Pre-Application Briefing to Committee

Reference No: PPA/2021/0030

Address: Sir Frederick Messer Estate,

Report of Formal Review: Sir Frederick Messer development

Landscape Design

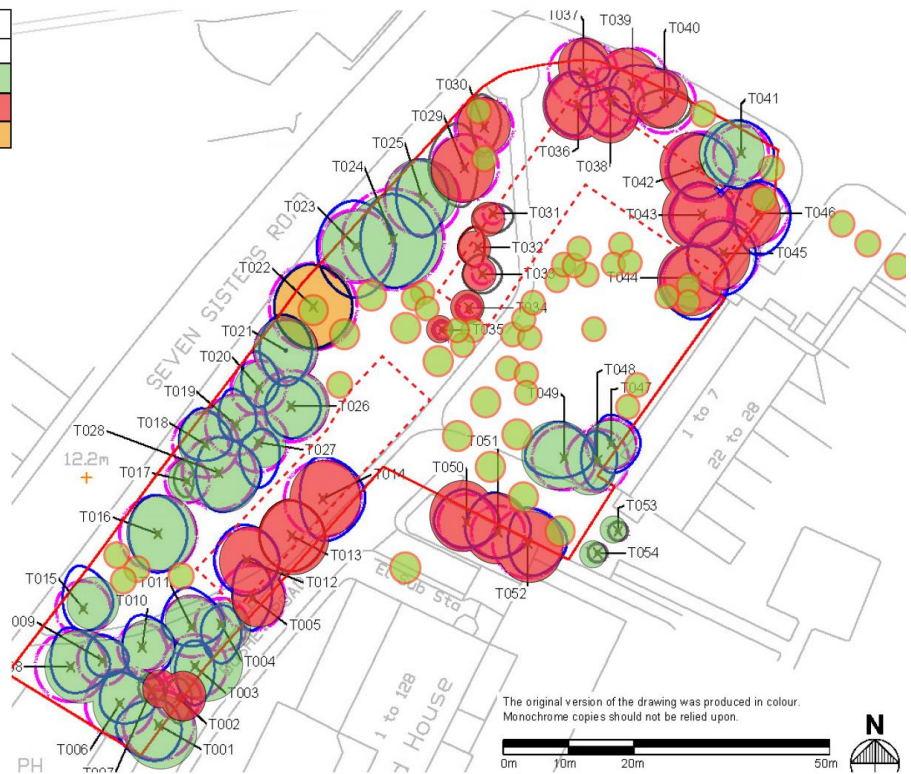
- It is essential that measures are put in place for the protection of existing tree roots and canopies, as well as the landscape features, throughout the construction phase of the project.

- Further thought should be given to the line of the new pedestrian route, to enable the mature tree on Seven Sisters Road to be retained.
- Further thought should also be given to relocating the new parking provision to avoid the loss of three mature trees and to create a more generous green space. The panel suggests that this might be a good location for the green roofed / earth mounded cycle storage.
